Comments on the Draft Report  
by the California Council on Science and Technology  
“Health Impacts of Radio Frequency from Smart Meters”

by Daniel Hirsch<sup>1</sup>  
31 January 2011

Figure A. Comparison of Radio-Frequency Levels to the Whole Body from Various Sources in  $\mu\text{W}/\text{cm}^2$  over time [corrected for assumed duty cycle and whole body exposure extrapolated from assumed cell phone dose at ear].

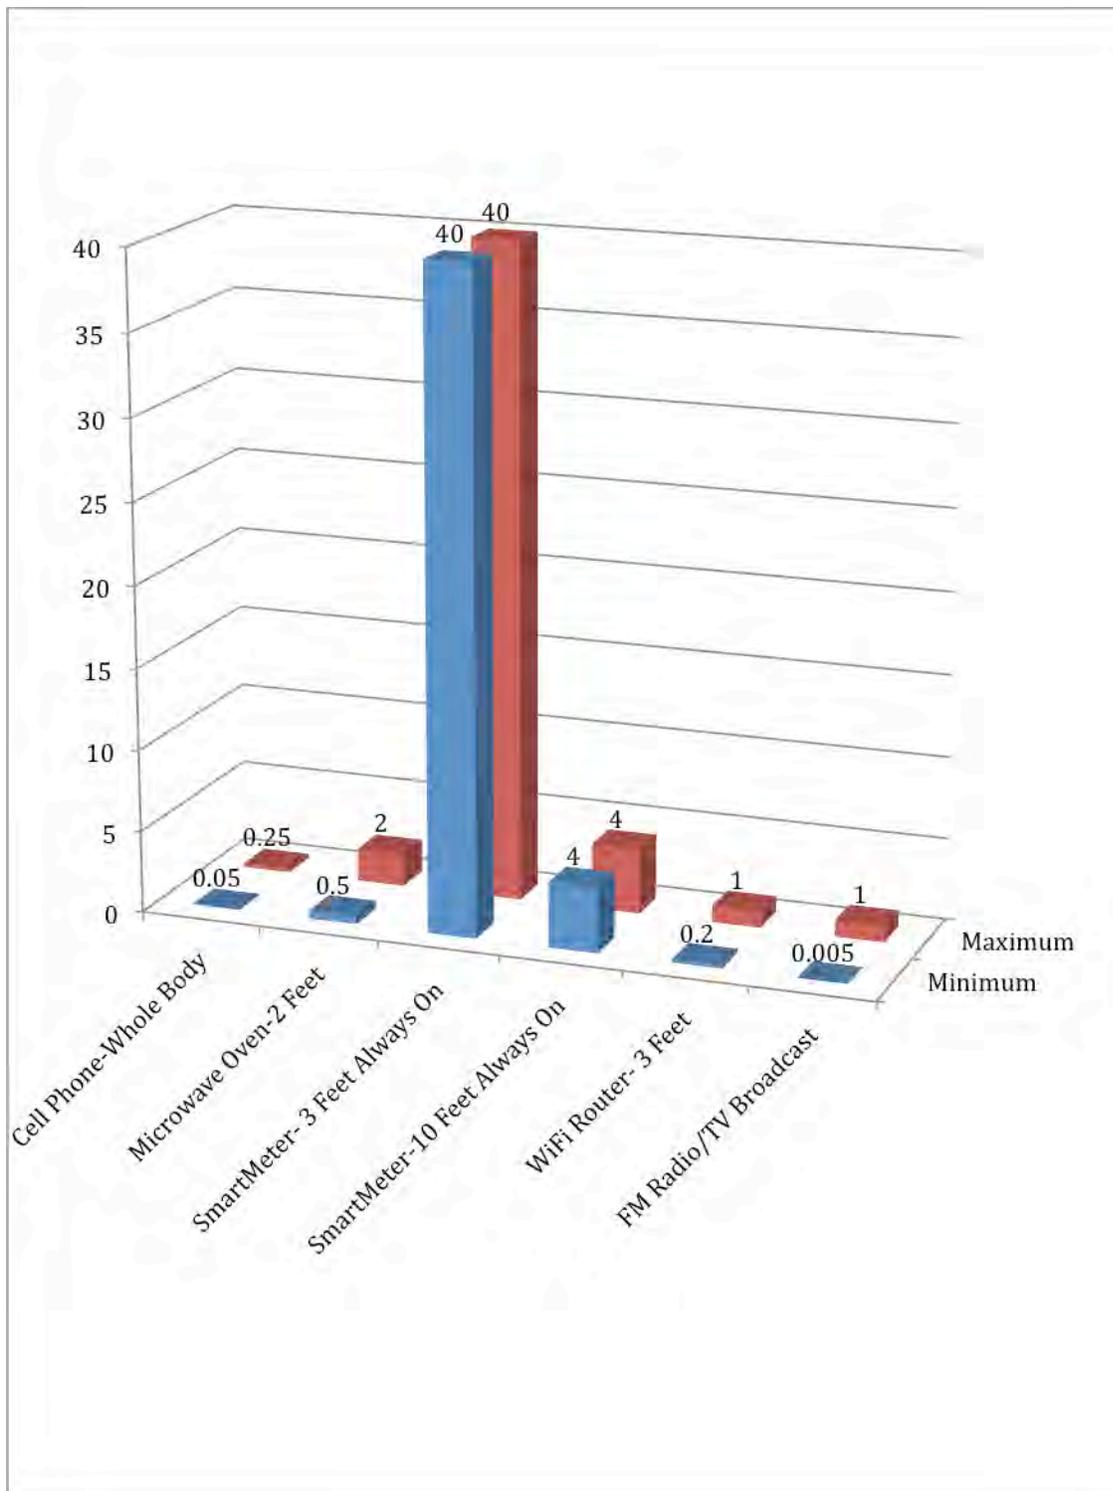
A summary figure below shows how rough estimates of the effect of those corrections suggest SmartMeters may produce cumulative whole body exposures far higher than that of cell phones or microwave ovens.

It is strongly recommended that CCST revise its Draft Report and conduct actual measurements of cell phone, microwave oven, and SmartMeter RF cumulative whole body power densities. If measurements aren't made, then rigorous calculations correcting for cell phone and microwave oven duty cycles and whole body exposures should be made.

Figure 1: Graph from CCST Report in  $\mu\text{W}/\text{cm}^2$ —uncorrected for whole body exposure or duty cycle

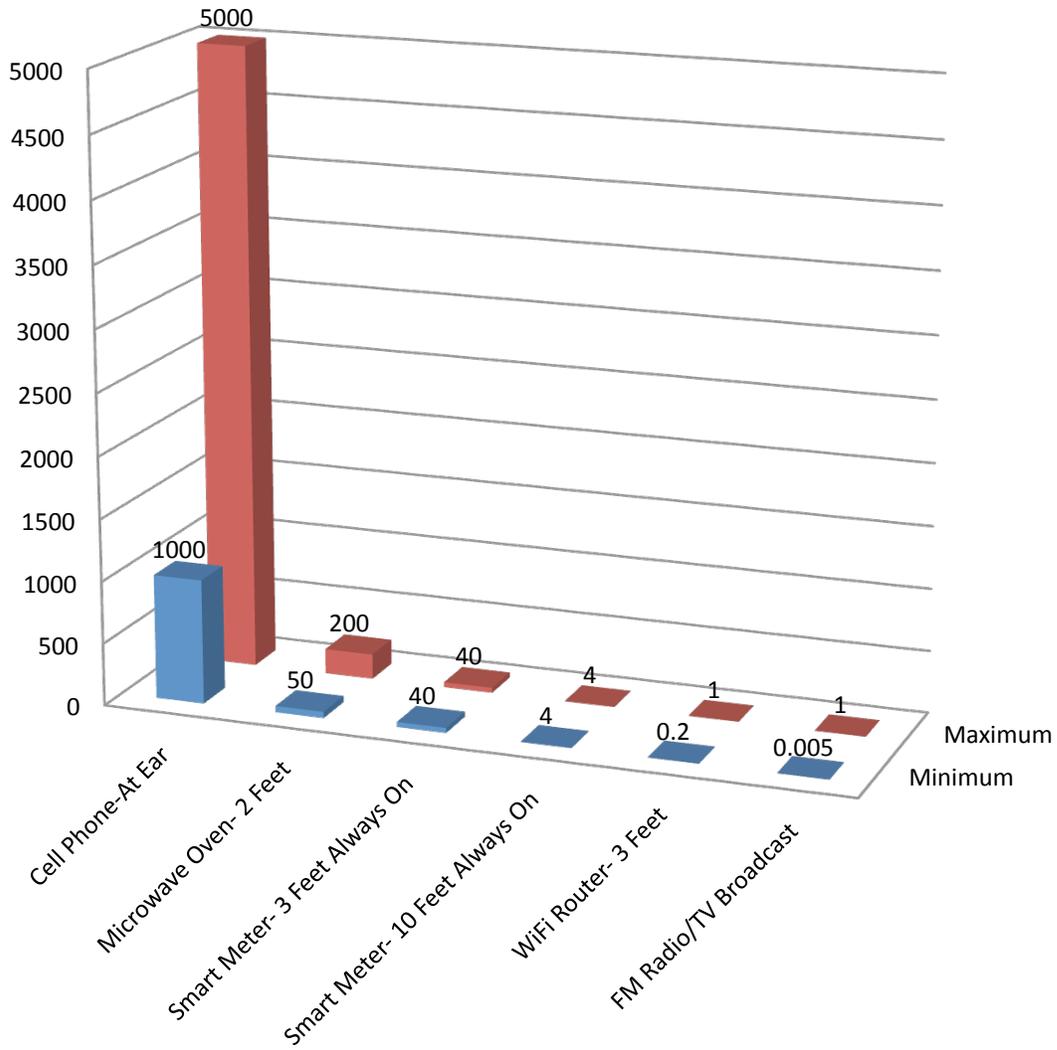
However, the CCST draft report does not appear to include much if any independent work on the subject but rather merely pastes in a table taken from an 8-page pamphlet released a few weeks earlier by the Electric Power Research Institute (EPRI), an advocacy group for the

electric power industry.<sup>2</sup> This EPRI table and the graph made from it constitute the core of the CCST report, and is reproduced here as Figure 1.

Note also that the estimates for exposure from a single SmartMeter contained in the EPRI item and repeated in the CCST draft is not a measured value but estimated—how is not made clear. EPRI's measurements were for a bank of ten SmartMeters; it didn't measure one alone but somehow estimated for it, despite the difference in how exposure falls off from one versus ten. The latter is inverse of the distance, the former inverse square of the distance. One presumes the electeds wanted actual measured values from an independent source, not a calculated value from the electric industry, without even an explanation of how it is was calculated and without independent verification.

HOWEVER, CCST did not correct numerous other apparent errors from the EPRI brochure when it adopted EPRI's values. For example, for cell phone exposures, CCST did not correct for the presumed duty cycle of the cell phone (which CCST indicates on average is 1%). Nor did it convert the EPRI cell phone power density estimate into comparable units. EPRI (and thus CCST) compared a *whole body average* exposure to SmartMeter radiation to *peak exposure to the ear* for the cell phone. One needs to compare apples and apples, or whole body exposures to whole body exposures. Comparing the peak dose to the ear from a cell phone, when the rest of the body gets vastly less radiation, with a whole body exposure where all organs get roughly the same dose from a SmartMeter, doesn't seem appropriate. If there is a cancer effect, it is likely associated with the total RF energy the body receives.

Figure 1 is simply the CCST Figure 1, which in turn was largely taken from the estimates in the EPRI pamphlet. Units were simply converted by CCST from mW/cm<sup>2</sup> to μW/cm<sup>2</sup> and it corrected the duty cycle for the SmartMeter, otherwise the data are unchanged from EPRI's estimates. One will note that the estimated exposure from the cell phone is just to the ear, in direct contact with the cell phone, whereas the other comparisons, including the SmartMeter, are for whole body exposures, and that the duty cycle of the cell phone and microwave oven were not corrected. In other words, the chart compares a SmartMeter that is always on with a cell phone or microwave oven when they are being used, even though 99% of the time they are not in use. This overestimates the cumulative exposure by a factor of 100 for the cell phone and microwave oven, and dramatically skews the comparison.

Figure 2. Comparison of Radio-Frequency Levels from Various Sources in  $\mu\text{W}/\text{cm}^2$  over time [corrected only for assumed duty cycle].

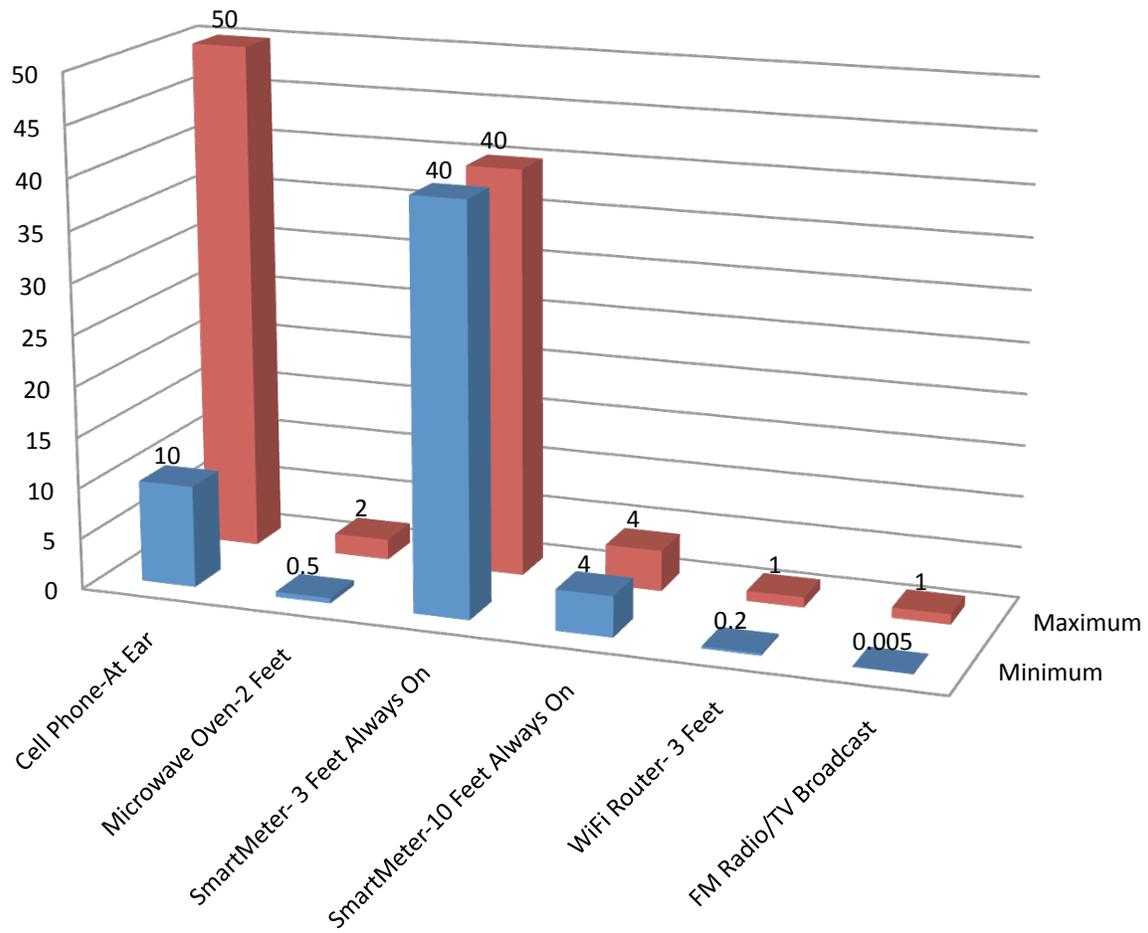
Figure 2 fixes the error regarding duty cycle for the cell phone and microwave oven, markedly altering the comparison. The minimum cumulative exposure over time from the SmartMeter at 3 feet is 80 times the minimum cumulative exposure from the microwave oven and four times the minimum cumulative exposure from the cell phone, for example. This does not involve any correction of the while-on exposure values for either the cell phone or microwave oven, only the duty cycle factor.

Figure 3. Comparison of Radio-Frequency Levels to the Whole Body from Various Sources in  $\mu\text{W}/\text{cm}^2$  over time [corrected for assumed duty cycle and whole body exposure extrapolated from assumed cell phone dose at ear].

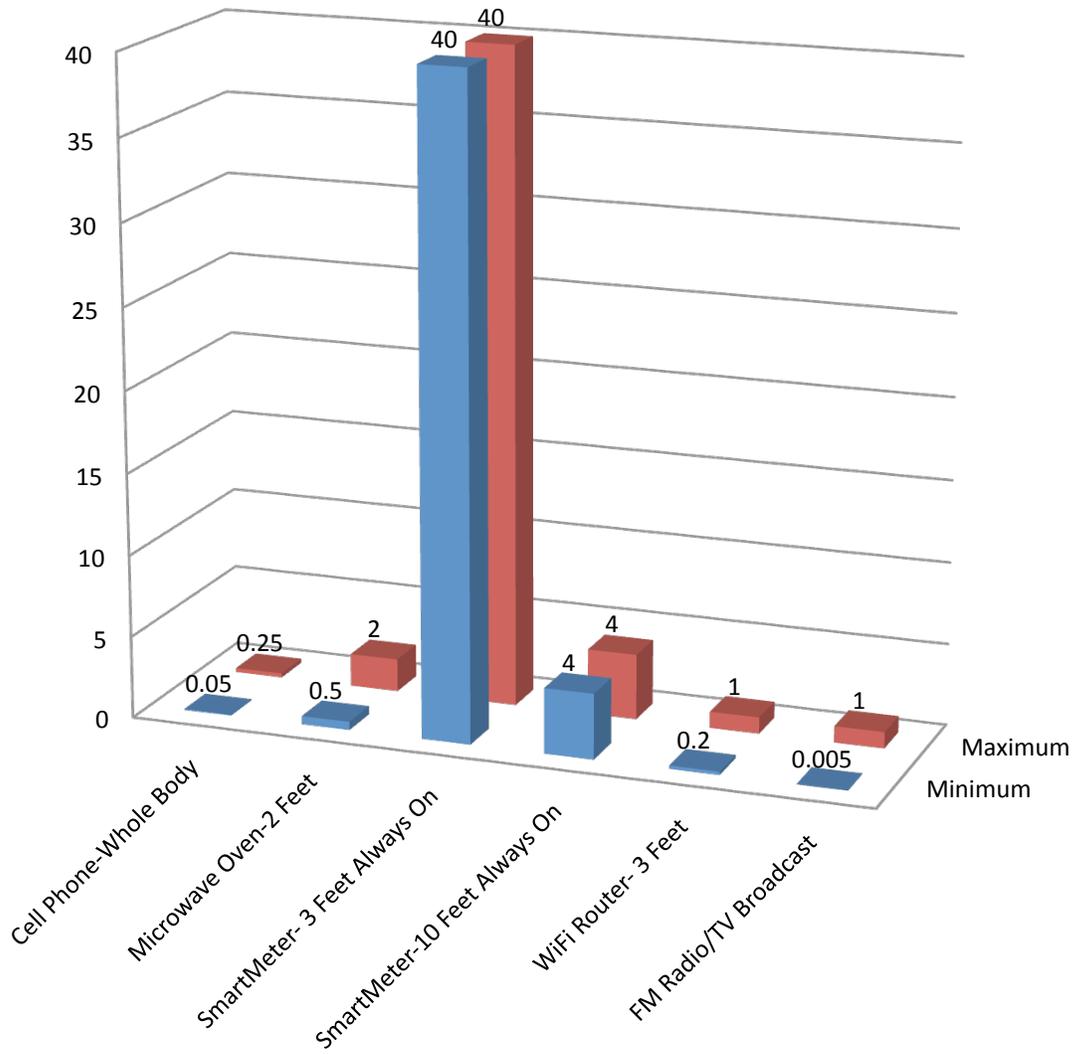
Figure 3 provides a very rough approximation of the correction of the cell phone at the ear estimate to a whole body estimate so it is comparable to the whole body estimate for the SmartMeter. *It should be stressed that neither this estimate nor that in Figure 4 using a different approach is intended to be a definitive figure, but is intended to be exemplary of the kind of change to the comparison a detailed analysis may produce. It is my recommendation that CCST carefully measure, or at minimum thoroughly calculate, the average power density over the whole body from a cell phone held at the ear. We here have made two very rough estimates just to make the point what a far more detailed analysis may show.*

The value used for the peak cell phone power density for a cell phone held to the ear in the CCST draft report is taken directly from the EPRI pamphlet, without apparent independent review or correction. According to p. 6 of the EPRI pamphlet, the value it gives apparently is not a measured value but an estimate. How the estimate was arrived at is not detailed in the brochure. All that is said is in footnote 1, “Based on a 3-inch 250mW antenna emitting in a cylindrical wavefront.” A quick calculation to try to reproduce what EPRI must have done indicates that if it merely assumed that all of the energy from a 250mW cell phone was transmitted by holding directly against the ear into a circular area with a 3 inch diameter, the power density in that small circular area around the ear would be 5 mW/cm<sup>2</sup>. That is precisely the upper value given by EPRI in its table. We don’t know if that is what EPRI did, since it doesn’t tell us what it did and CCST does not appear to have tried to confirm the asserted value. But in any case, 5 mW/cm<sup>2</sup> from a 250mW cell phone would indeed appear to require that that power be deposited solely in that very small circular area.

Averaging over the full potentially exposed surface area of the body (presuming only half the body surface could be exposed to the cell phone from any one angle), the whole body exposure would be approximately on average 0.25 mW/cm<sup>2</sup> given the maximum value to the ear of 5 mW/cm<sup>2</sup> put forward by EPRI and the CCST draft report and correcting as well for the duty cycle. **The SmartMeter thus would produce 160 times more cumulative whole body exposure than the cell phone assuming this estimate for whole body exposure.** This is shown in Figure 3.<sup>3</sup>

Figure 4. Comparison of Radio-Frequency Levels to the Whole Body from Various Sources in  $\mu\text{W}/\text{cm}^2$  over time [corrected for assumed duty cycle and whole body exposure extrapolated from EPRI/CCST SmartMeter estimated levels at 3 feet].

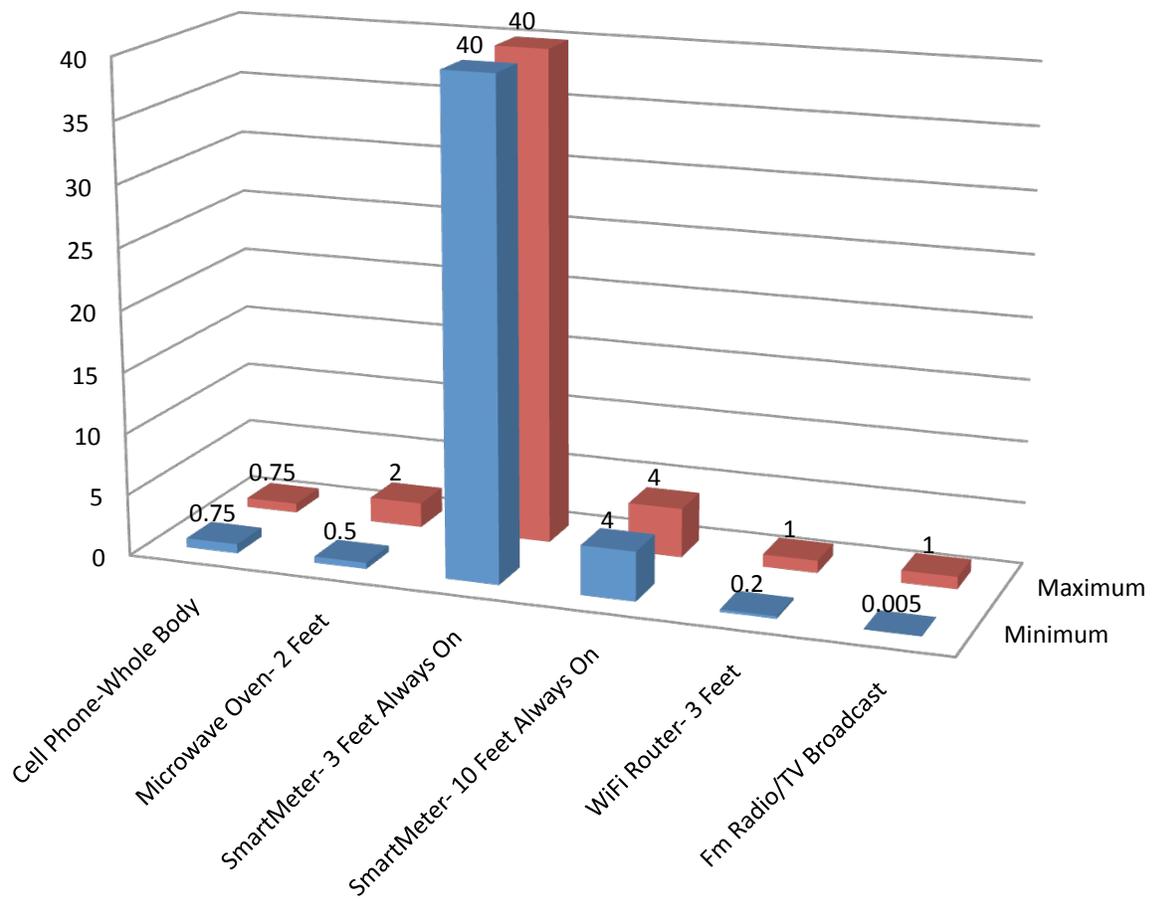
Since the EPRI estimate for cell phone peak power density at the ear is unexplained as to its derivation, we have also made a very rough estimate of whole body exposure from a cell phone from an independent line of calculation. Taking the values EPRI (and thereby CCST) put forward for exposure at three feet from a 250 mW SmartMeter, and noting that EPRI assumed the cell phone would also be 250mW, one can make a rough estimate of power density for the whole body from a cell phone held at the head. The exposure at one's waist would be approximately three feet from the source, just as in the assumed case of the SmartMeter. Presuming that the dose falls off as the inverse square of the distance, a very rough estimate of power density averaged over half the surface of the whole body, and taking into account duty cycle, yields a cumulative cell phone whole body power density of roughly  $0.75 \mu\text{W}/\text{cm}^2$ . **Using this way of estimating suggests the SmartMeter would produce 50 times the cumulative whole body exposure as a cell phone.** The results of this comparison are found in Figure 4.
